TO: Advisory Board on Radiation and Worker Health, Work Group on TBD-6000
FROM: Robert Anigstein and John Mauro, SC&A
SUBJECT: Review of NIOSH Response Paper: July 10, 2015
DATE: September 11, 2015

Review of “Responses to Sanford Cohen & Associates Review of Battelle-TBD-6000 Appendix BB (General Steel Industries, Rev. 1),” Response Paper

Figure 1. Betatron Radiography of the Axle of a Power Shovel Cast at GSI
(Courtesy of ██████████)

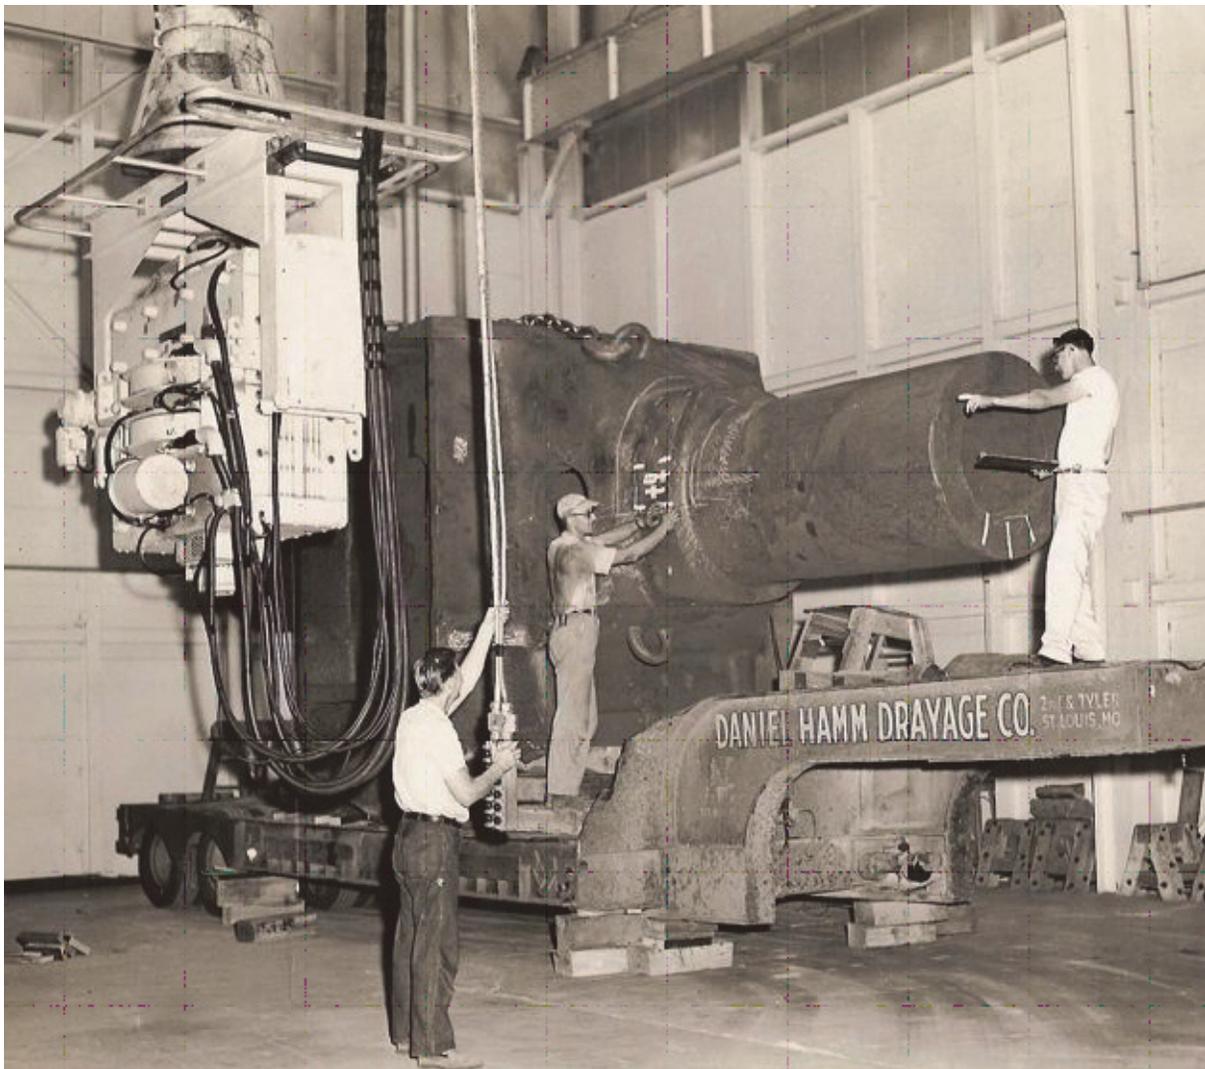
There are no relevant data that would support the assumption of 15 min between shots. Mr. ██████████ reported taking 12–15 s to transport the radium source from the lead pig, which was kept inside the radiography room, and position it for the exposure. It would not have taken much longer to position and remove the films, which would have been also stored nearby. It was not necessary to develop each film prior to exposing the next one. According to the Atomic Energy Commission's (AEC) "Compliance Inspection Report" (NRC 2009b), ██████████, the GSI ██████████ reported that the exposures ranged from 1 to 70 min. Assuming 2.4 h of exposure and 10 shots per shift, the average shot took 0.24 h ($[8 \times 0.3] \div 10 = 0.24$) or ~14 min. The longer shots provided ample time to develop the previously exposed films, which could be processed in batches. Since a typical casting was larger than one x-ray film, it took several exposures to radiograph one casting. There was no need to transport the casting between shots—repeat shots could have been taken in quick succession: position the film, position the radium

source, wait for the exposure to finish. This procedure bears no relationship to betatron radiography, which involved using electrical controls to move and aim the betatron apparatus and retiring to the control room to set the controls for the next shot. GSI workers have reported that the castings radiographed with the betatron tended to be large and complex, requiring a significant setup time. The very reason that the betatron was installed at GSI was to radiograph hulls of Army tanks and other castings that were too large for the isotope sources (^{226}Ra and later ^{60}Co).
